ADDENDUM 1 (PENDING DSA APPROVAL)

PROJECT: **Santa Ana College**
 Science Center

DATE: 8/23/2017

DSA File No.: 30-C2
DSA Applications No.: 04-115788
HGA Commission No.: 3584-001-00

NAME: JAMES C. MATSON
 DATE: MAY 16, 2017
 REGISTRATION NUMBER: C13030

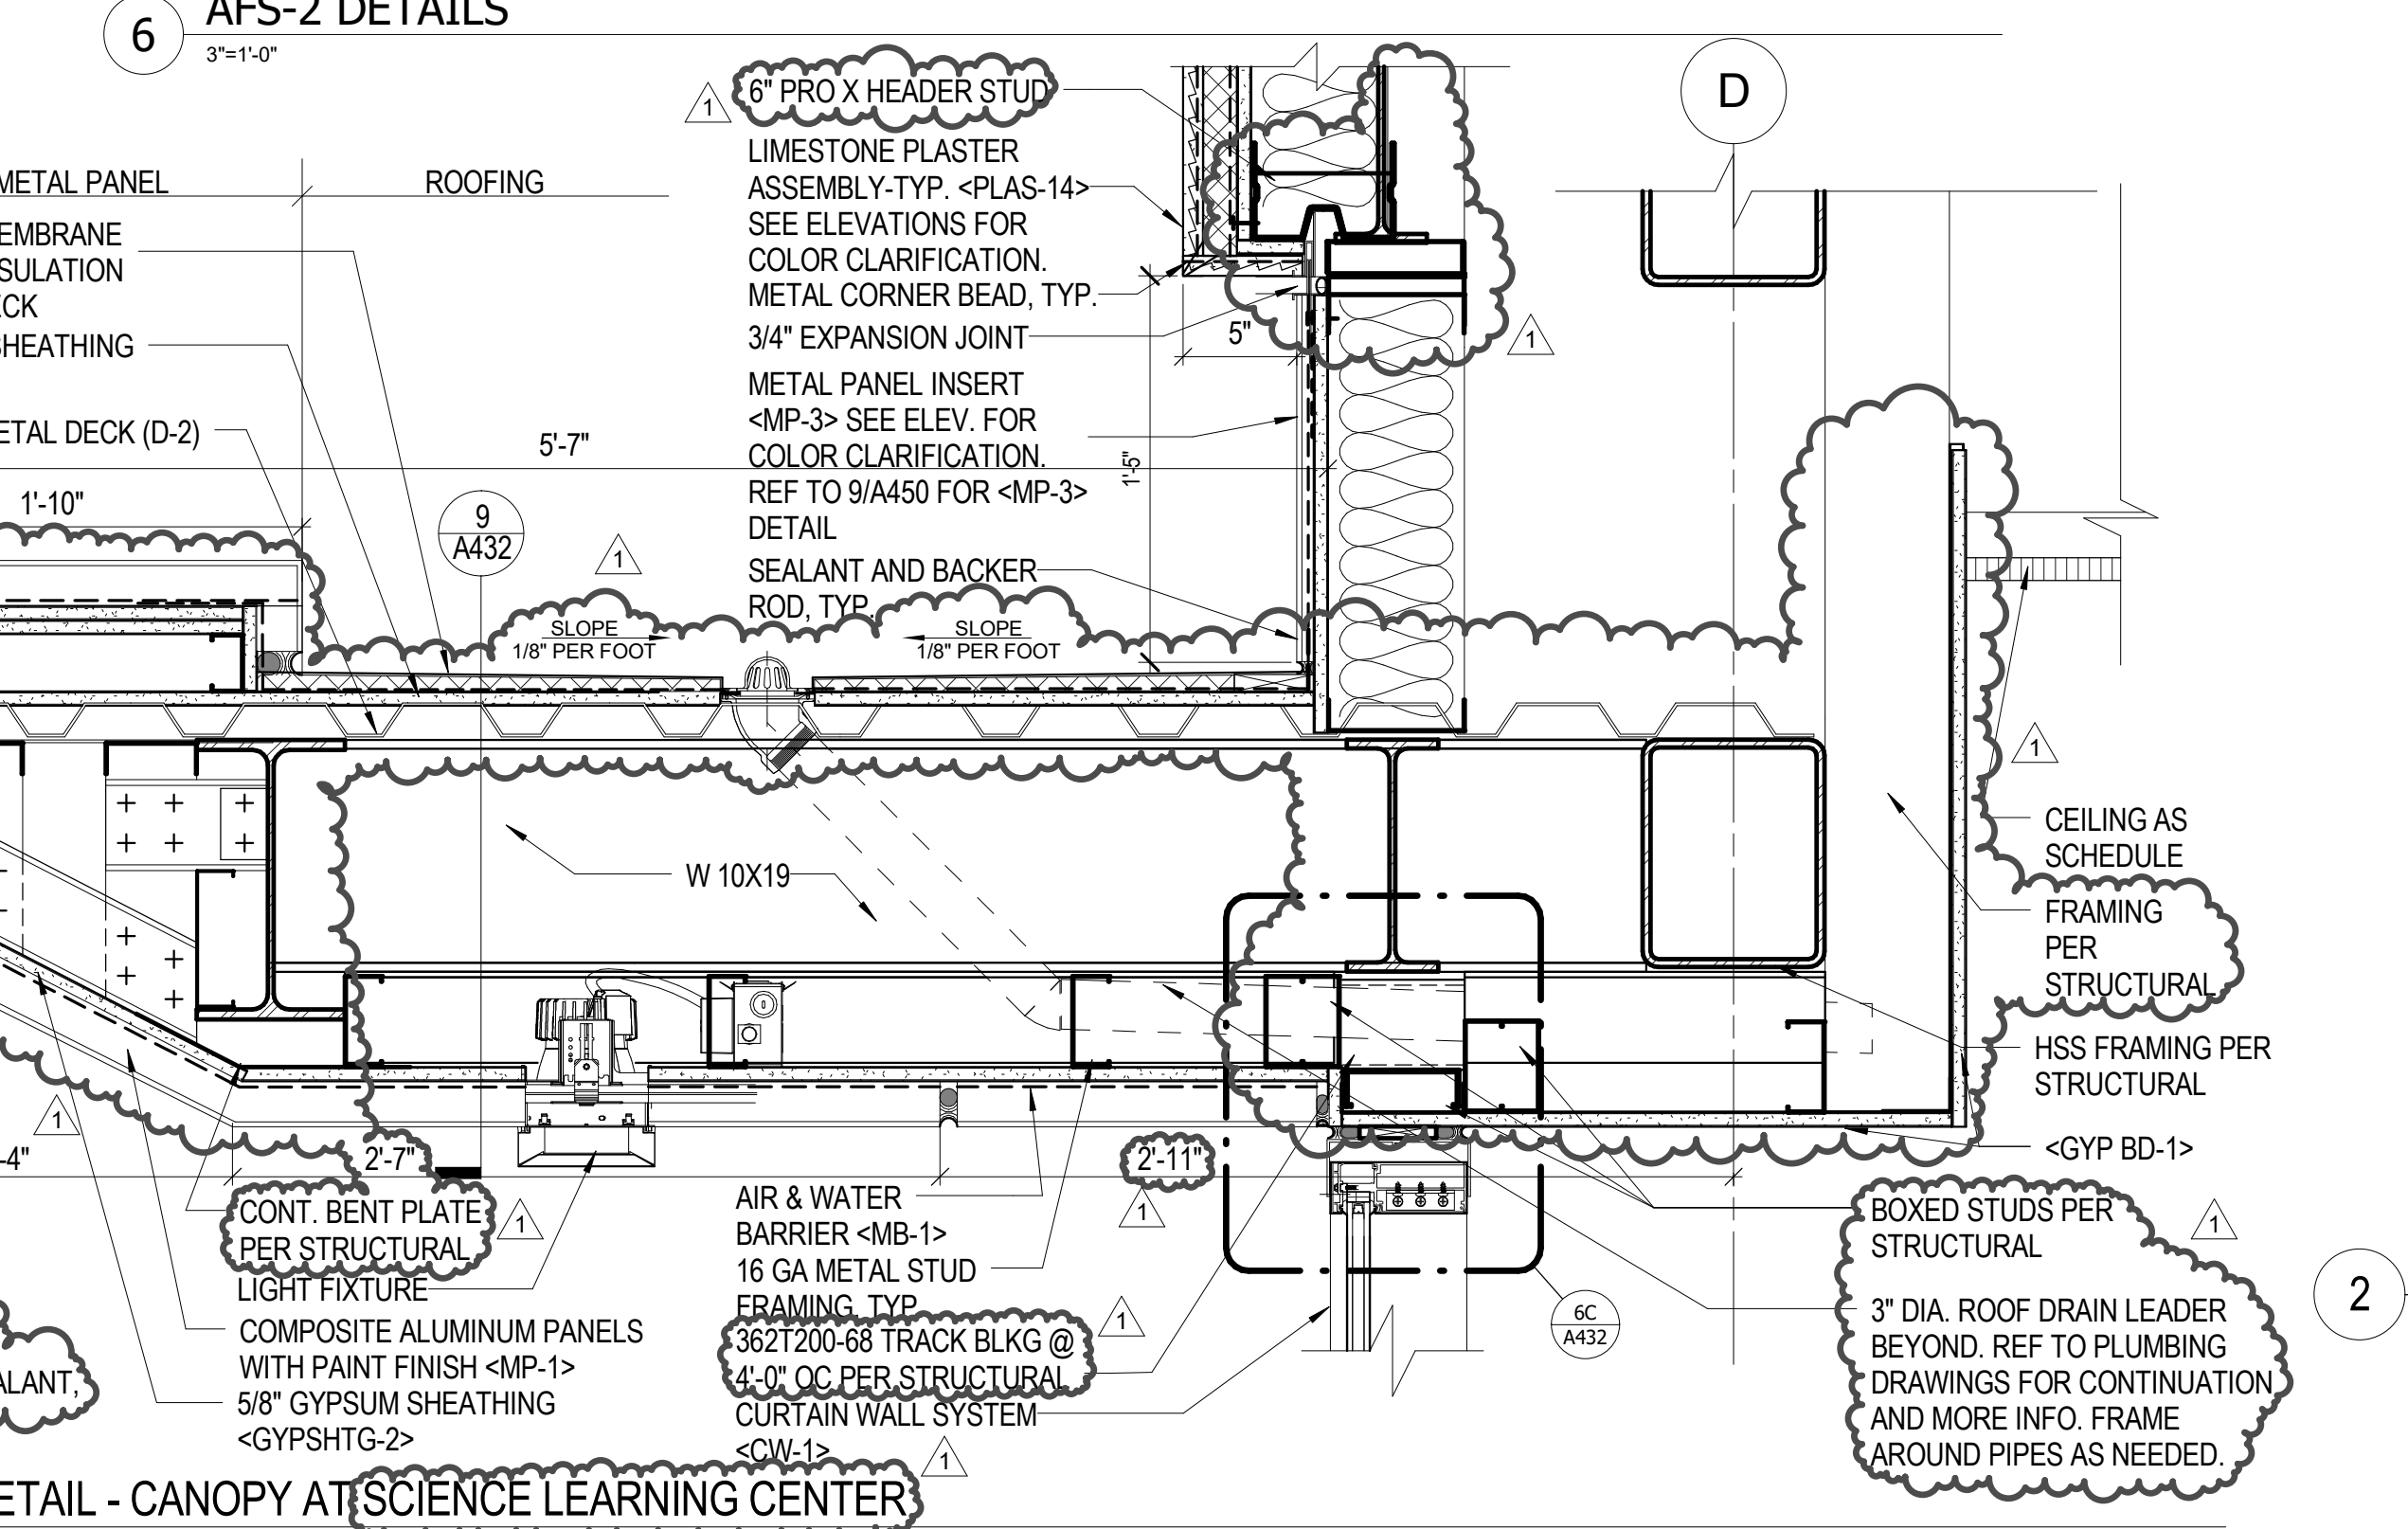
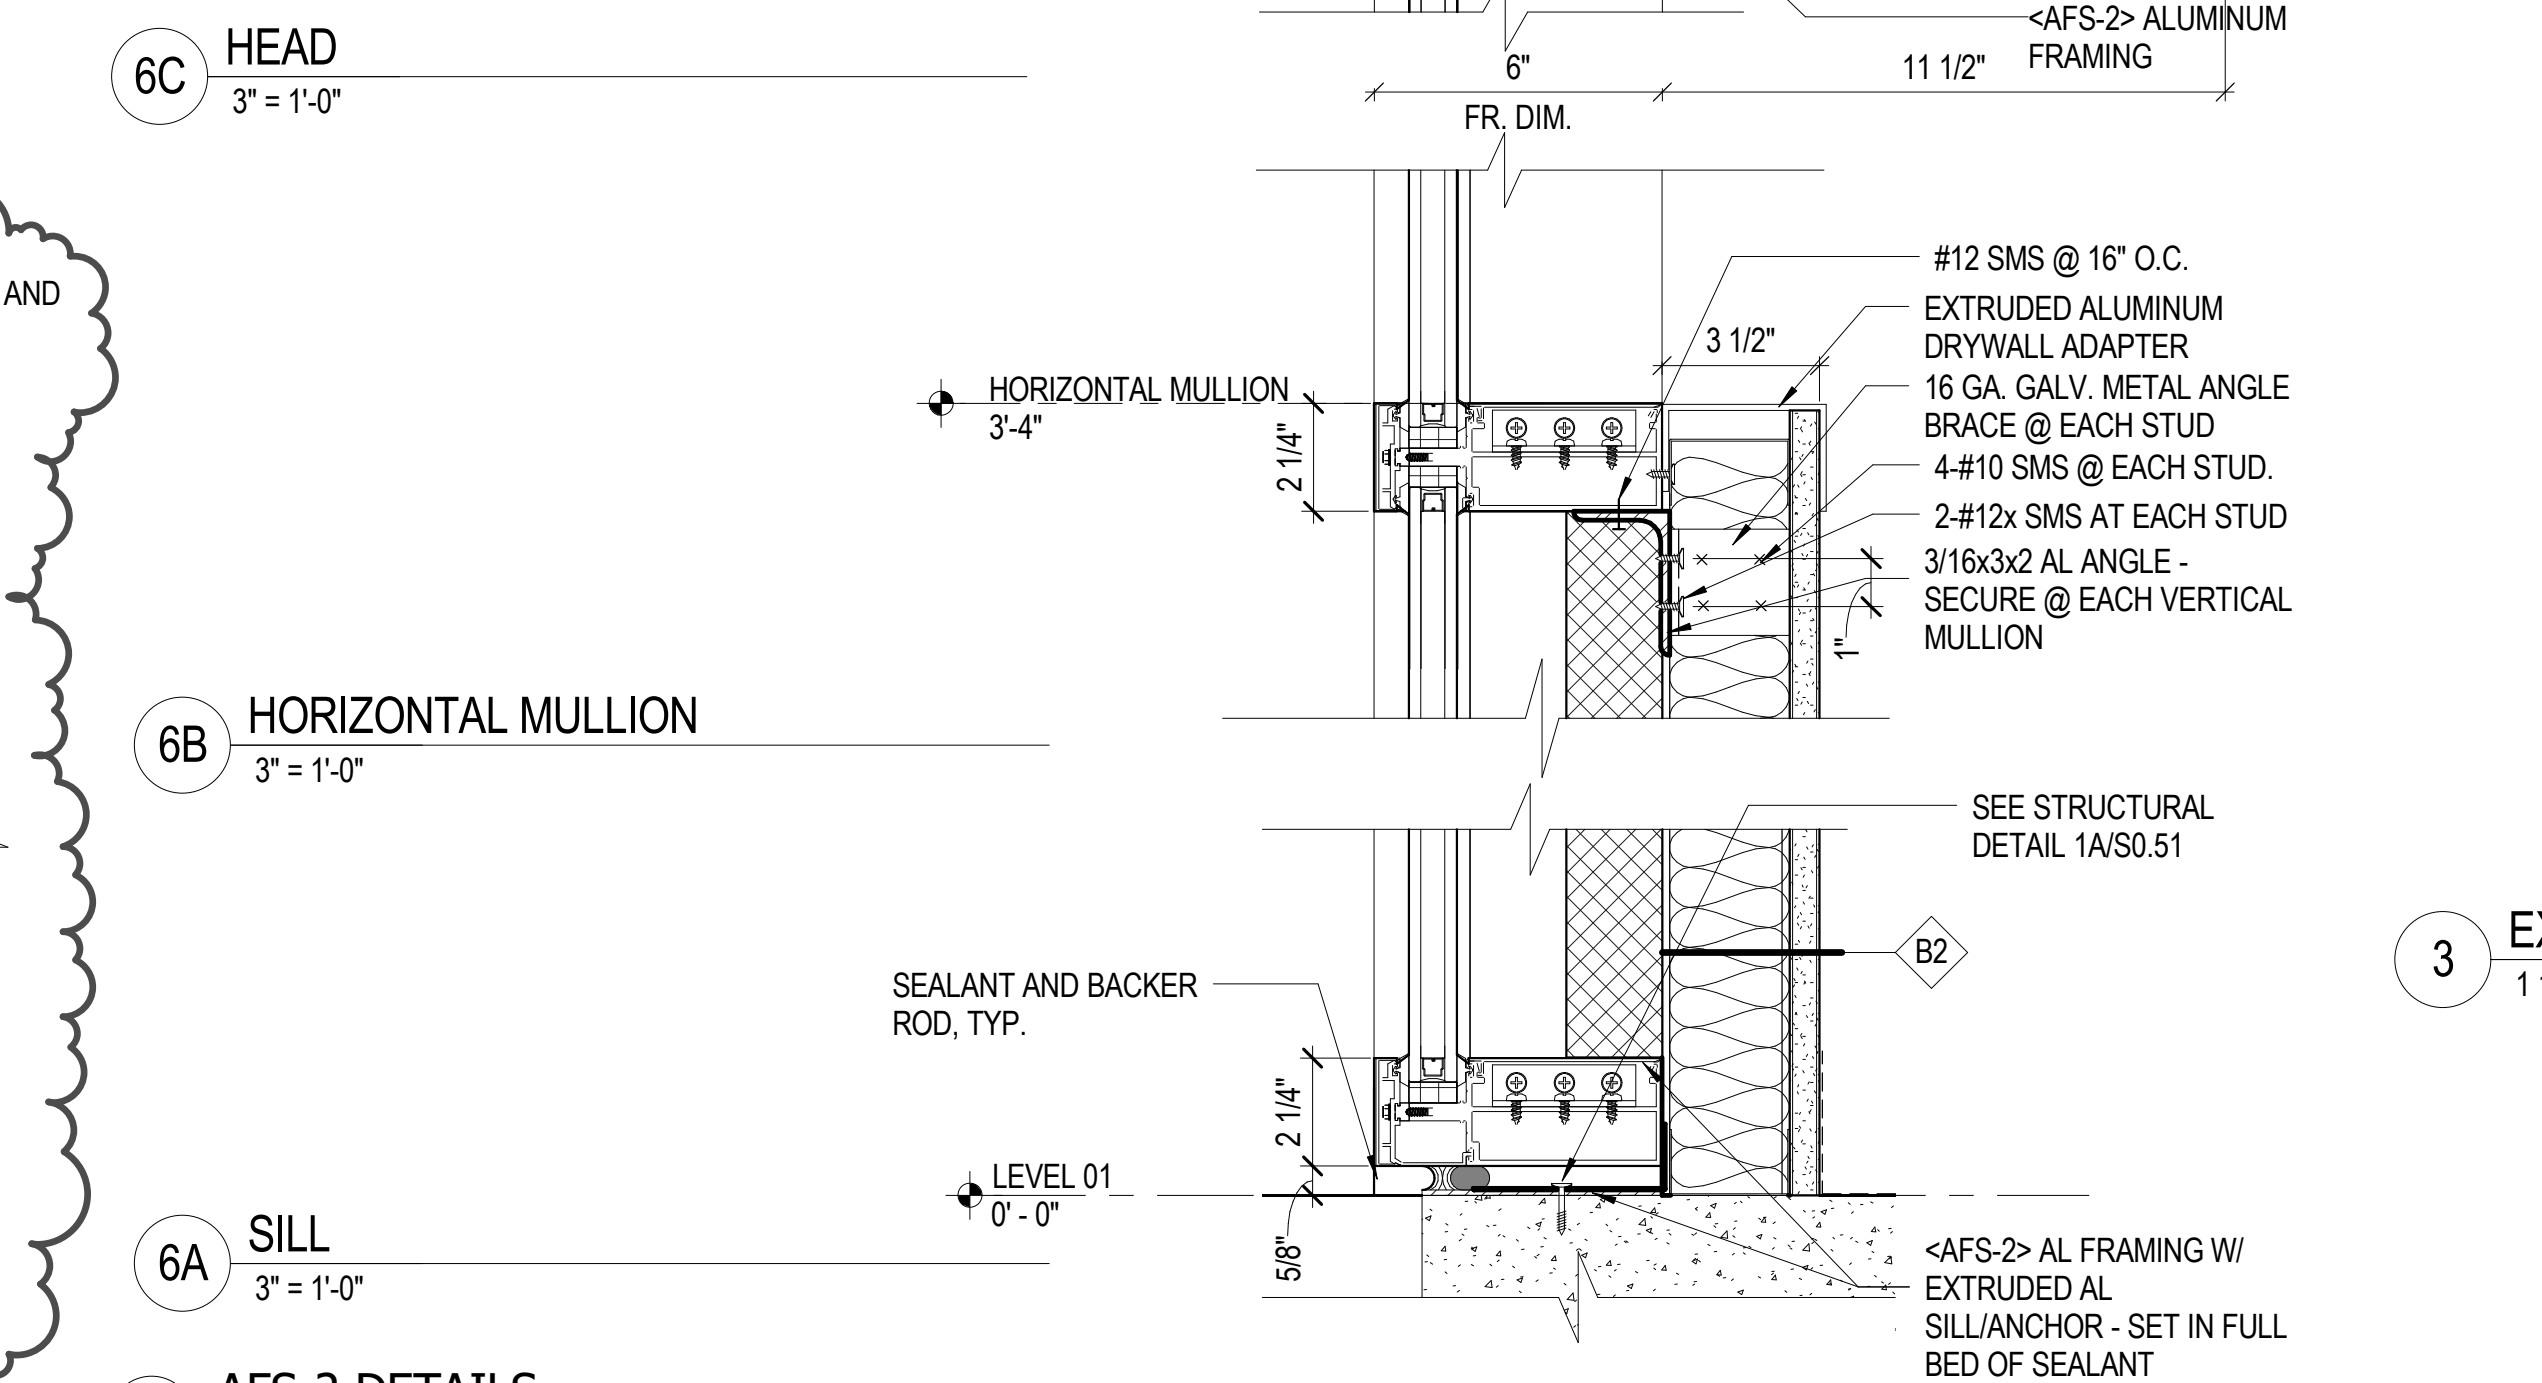
- North canopy reduced by 5'-0" at Details 5, 8, and 9.
- Gutter removed from roof at north canopy at Details 5.
- Framing at canopy revised to match structural drawings at Details 5, 6C, 7, 8, and 9.
